## **Non-Concurrence Process Record for NCP-2012-009**

NCP TRACKING NUMBER  
NCP-2012-009

TITLE OF SUBJECT DOCUMENT  
ENDORSEMENT OF ELECTRIC POWER RESEARCH INSTITUTE FINAL DRAFT REPORT 10252

ADAMS ACCESSION NO.  
ML12319A074

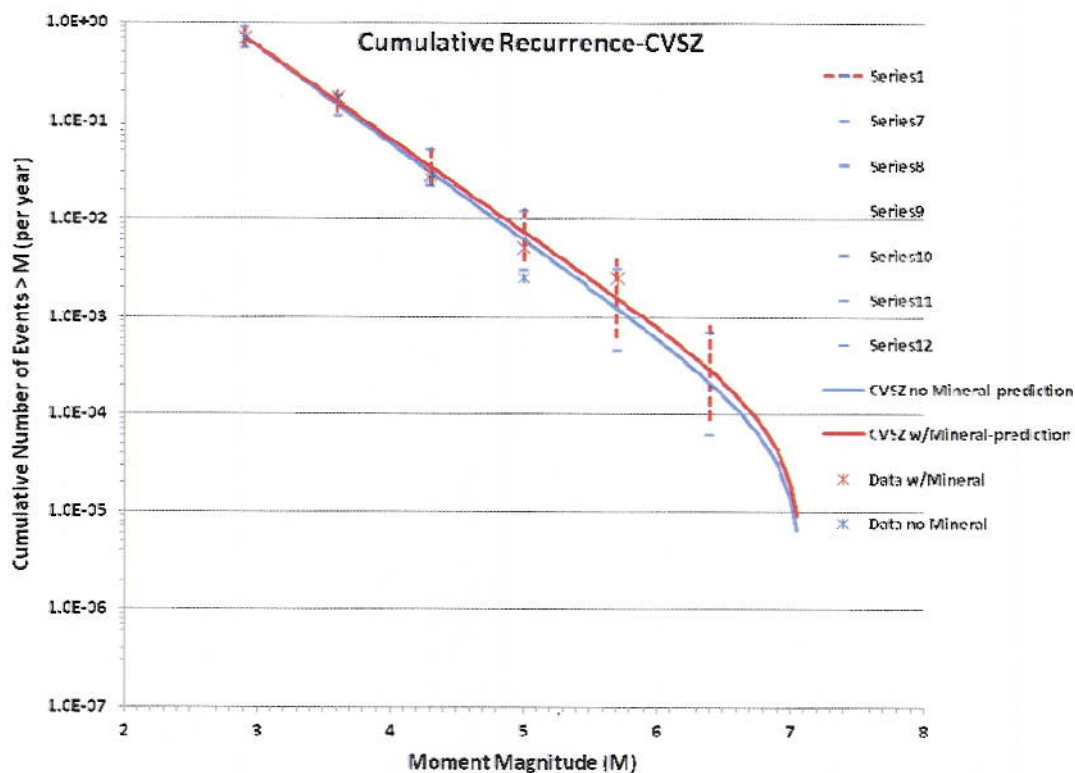
Prior to the publication of the final CEUS-SSC model earlier this year, the model developers evaluated the impact of the 2011 Mineral, Virginia earthquake and found that there would be little or no impact on any aspects of the model. The NTTF R2.1 seismic team has performed a confirmatory analysis of the Mineral, VA earthquake and determined that inclusion of this event in the CEUS-SSC earthquake catalog will not result in significant changes to the seismic hazard model. Figure 1 shows that the recurrence rates for the Central Virginia Seismic Zone both with (red line) and without (blue line) the Mineral, Virginia earthquake differ only slightly. In addition, Table 7.4.2-1 of the CEUS-SSC report (NUREG-2115) indicates that the lower bound of the maximum magnitude distribution for the ECC-AM (Extended Continental Crust – Atlantic Margin) source zone, which covers the Mineral, VA earthquake, starts at M6 and ends at M8, which exceed the magnitude of the Mineral earthquake. Hence, the occurrence of the Mineral earthquake does not challenge the existing maximum magnitude distribution for this source zone.

Figure 7.4.2-8  
Mmax distributions for the MidC-B seismotectonic zone

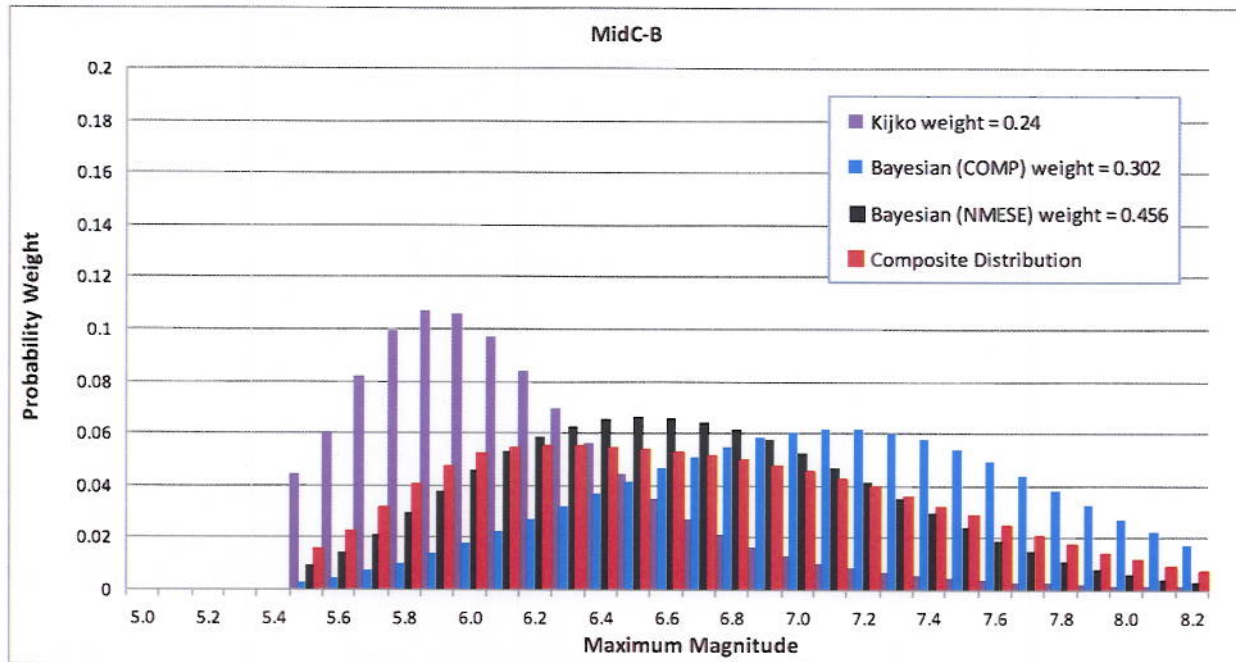
Similarly, Table 7.4.2-1 and Figure 7.4.2-8 from NUREG-2115 (included below), illustrate that the magnitude of the November 11, 2011 M5.6 Oklahoma event is equal to the lower bound of the maximum magnitude distribution (M5.6 to M8.0) for the Mid C-B (Mid-Continent-Geometry B) seismic source zone that is implemented in the hazard calculations. Table 7.4.2-1 illustrates two additional points. First, any change to the underlying distributions to incorporate the occurrence of the M 5.6 event will impact only the lower bound portion of the final distribution. Second, in the current implementation of the model, this lower bin is given the same weight as a M8 on the upper bound. Hence the maximum magnitude range for the Mid C-B seismic zone covers the M5.6 Oklahoma earthquake.

Figure 7.4.2-8 (NUREG-2115). Maximum magnitude distribution for the CEUS-SSC MidC-B seismic source zone. The 2011 M5.6 Oklahoma earthquake occurred within the Mid-B source zone. M5.6 is at the lower end of the composite distribution.

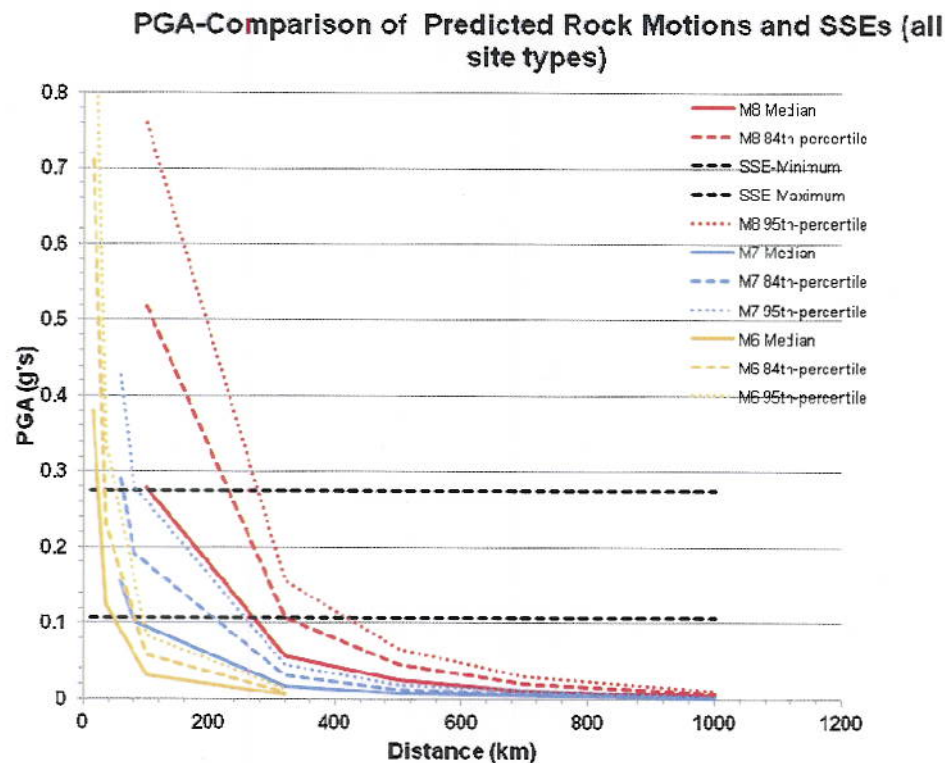
At very large distances, earthquake ground motions for even very large magnitude events are very low. [Figure 2](#) shows the peak ground acceleration (PGA) versus distance for earthquake magnitudes ranging from 6 to 8. Accelerations for each of the magnitudes are very low (about 0.1g) beyond 200 km. The black dashed line at 0.1g in [Figure 2](#) represents the minimum PGA for which all plants have to be designed even if the estimated PGA for the site is lower. Therefore, as shown in [Figure 2](#), the minimum required PGA of 0.1g is significantly greater than the estimated peak accelerations from distant seismic sources beyond 400 km. Going beyond to a distance of 1000 km, the estimated peak accelerations even from M8 earthquakes approach zero. Even at the low probabilities used to determine the GMRS ( $10^{-4}/\text{yr}$  to  $10^{-5}/\text{yr}$ ) ground motions at such large distances are negligible.

Figure 3. Comparison of shear-wave velocity profiles developed independently utilizing only the information in the Hope Creek FSAR (blue curves representing lower range, median, and upper range) with the single velocity profile used in the PSEG ESP site response analyses.

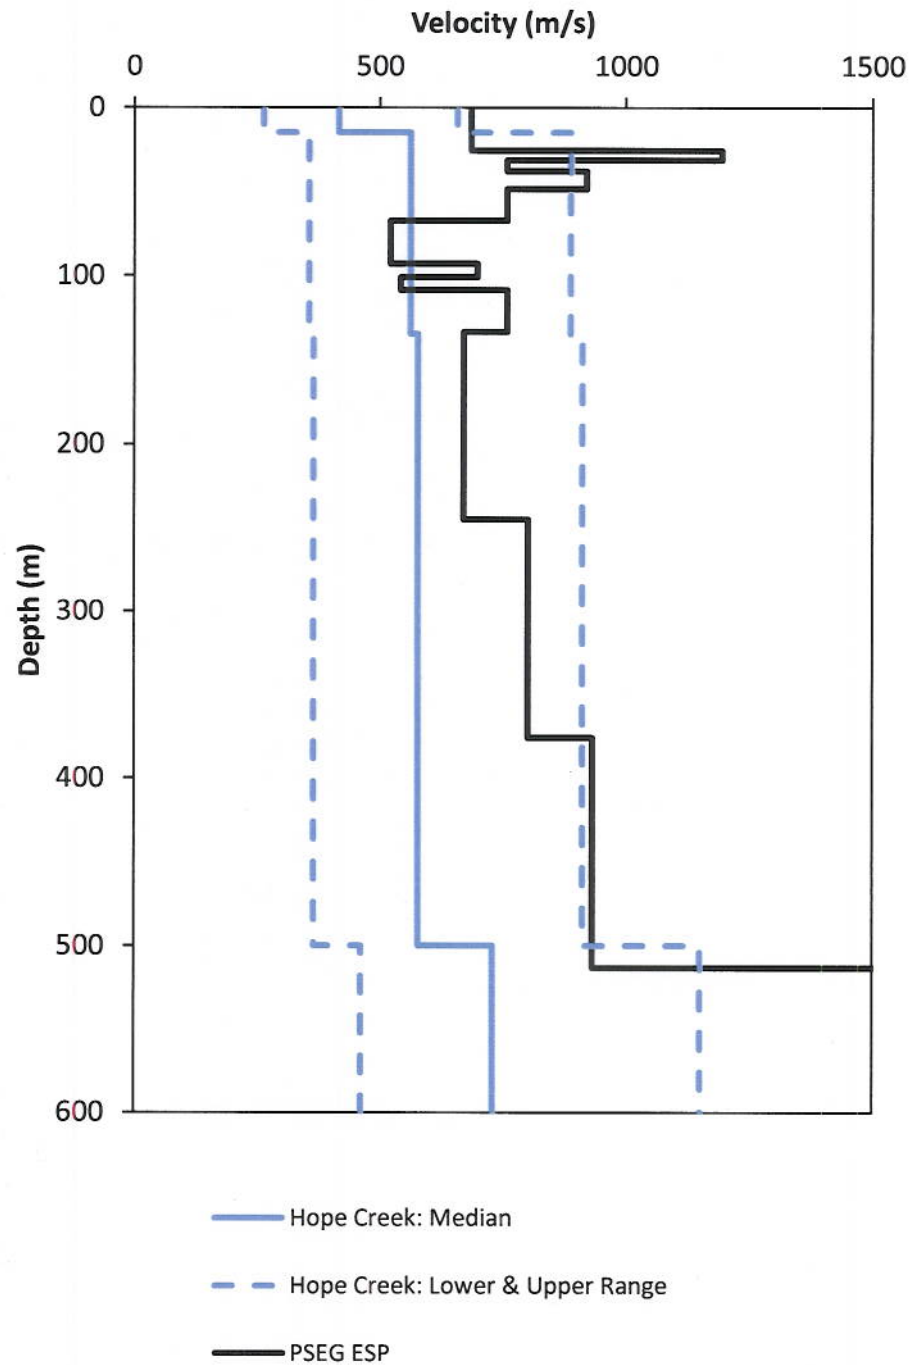
To exercise and evaluate the site response approach in the SPID, NRC staff performed a case study at an operating plant located next to an ESP site. The NTTF R2.1 Seismic Team

developed a geologic profile for the operating site based on the information and data in the FSAR using the approach in the SPID. This result was then compared with the modern data acquired by the ESP applicant for the adjacent site. Figure 3 shows that this ESP profile reasonably matches and falls within the three base estimates of the profile developed using the FSAR data and the SPID approach. Figure 4 shows that the application of the site response approach described in the SPID using the geologic information from the operating plant FSAR closely matches the results from the co-located ESP, which is based on direct geophysical measurements of the subsurface. What is important to note in Figure 4 is the comparison between 1 to 10 Hz. Determination of whether a plant SSE has been exceeded and additional plant risk evaluations are needed or not is based on comparing the SSE and GMRS in this frequency range. This is the important frequency range for many of the nuclear power plant structures, systems, and components. This comparison further shows that in a probabilistic analysis, due to randomization and multiple analyses, seemingly large variations in profiles and properties are much less important in the aggregated results, such as the mean amplification factors shown in Figure 4.

**Figure 2.5.10.** Combined Plot of Fractile S-Wave Models for SASW and Checkshot Surveys the Saddle Mountains Basalt. Also shown is the DC-1 inferred model for two hypothetical values of  $V_p/V_s$ .

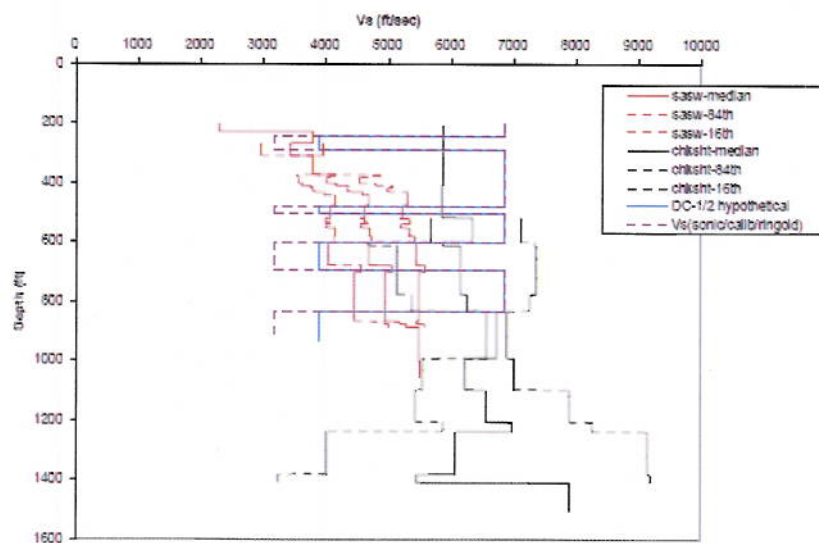
The figure below illustrates the level of uncertainty that often arises in the characterization of a particular site. It shows the measured shear-wave velocity profiles measured at a DOE site. These data were acquired recently using modern techniques. Based on the number of detailed investigations performed, this would be described as a "well-characterized" site. It is clear that

the predicted velocity profiles are subject to considerable uncertainty associated with the method used to measure in-situ shear-wave velocity. This uncertainty will vary with the characteristics of the site and the type of measurement technique being used. It is not accurate or appropriate to infer that even well-characterized sites have no uncertainty associated with the site profiles. This uncertainty in the estimates of shear-wave velocity results in uncertainty in the site response.

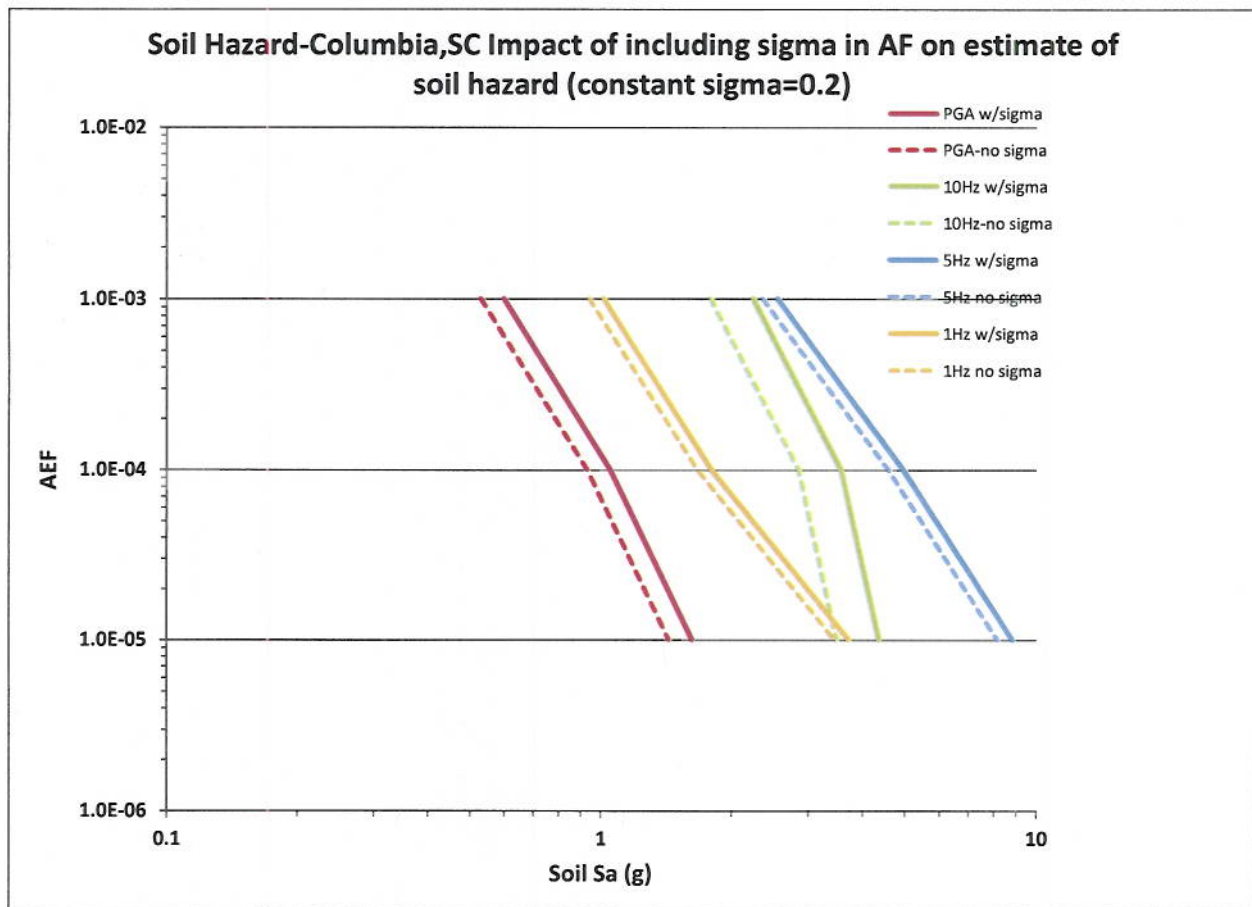
The approach currently utilized in the development of the GMRS for COL/ESPs utilizes a mean estimate of the site-specific amplification function for those sites not located on hard rock. The approach described in the SPID explicitly incorporates the full uncertainty distribution in the calculation of the soil hazard. This approach is conservative relative to the approach utilized in the COL/ESPs. An example of this effect is shown in the Figures 5 and 6 below.

The NRC NTTF Seismic staff concludes that the approach outlined in the SPID realistically evaluates the impact of uncertainty in site and material properties on estimates of the site-specific seismic hazard. Increased uncertainty in the site amplification function results in conservative estimates of the seismic hazards relative to approaches that do not explicitly incorporate this uncertainty. The effect of increased uncertainty in the site amplification functions on the computed soil hazard is illustrated in the figure below. Using this approach, the NTTF R2.1 Seismic Team believes that a reasonable estimate of the site-specific hazard for most sites can be determined. The estimate of the GMRS derived from the site-specific seismic hazard is used to determine if further risk evaluations of the nuclear power plant in the form of a seismic PRA or seismic margins analysis is warranted.
